**RE:** AFD Fire Station 4

**Grading and Drainage Plans Engineer's Stamp Date: no stamp**

Hydrology File: H14D120

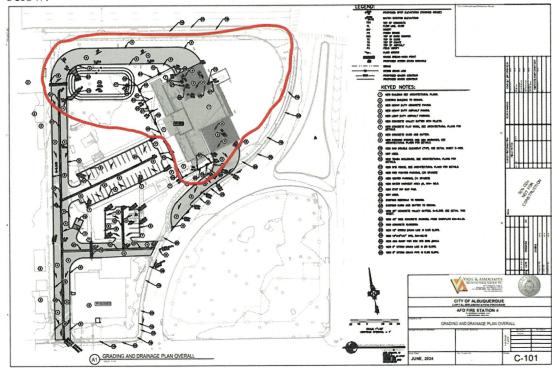
- 6. Pond Sizing: The required size of the detention pond will be for the detention of water volume for the difference between the existing and proposed development.
- 7. Verify that the pond volume will be sufficient to capture the flows from the area shown below.
